- EFFECTIVE DATE:** This NOTIFICATION is effective June 29, 2007
- SUBJECT:** Flap Handle Fatigue Cracks
- MODELS AFFECTED:** CC11-100 S/N CC11-00002 thru CC11-00050 that have the original part as shown in Figure 2 below.
- COMPLIANCE TIME:** Every 100 hours or during annual inspection whichever comes first.
- PURPOSE:** Flap Handle Fatigue Crack Inspection
- INSTRUCTIONS:**
1. Inspect flap handle in location shown in Figure 1 for cracks.
 2. If cracks are found, contact Cub Crafters Inc. for further information and instruction.
 3. For aircraft that have an upgraded flap handle, the requirement for inspection is terminated. See Figure 2 for cross-sectional views of upgraded and original parts.

NOTIFICATION

NB00003

Rev B

Figure 2 – Inspection Location

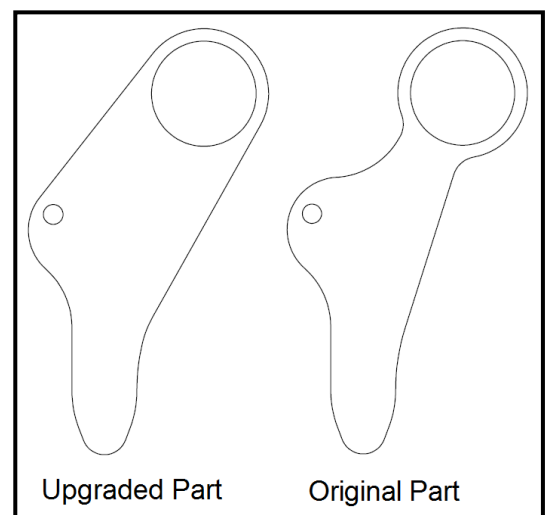
Aircraft with Flap Handle Assembly P/N SC32200-001 Rev G or later have an upgraded flap handle.
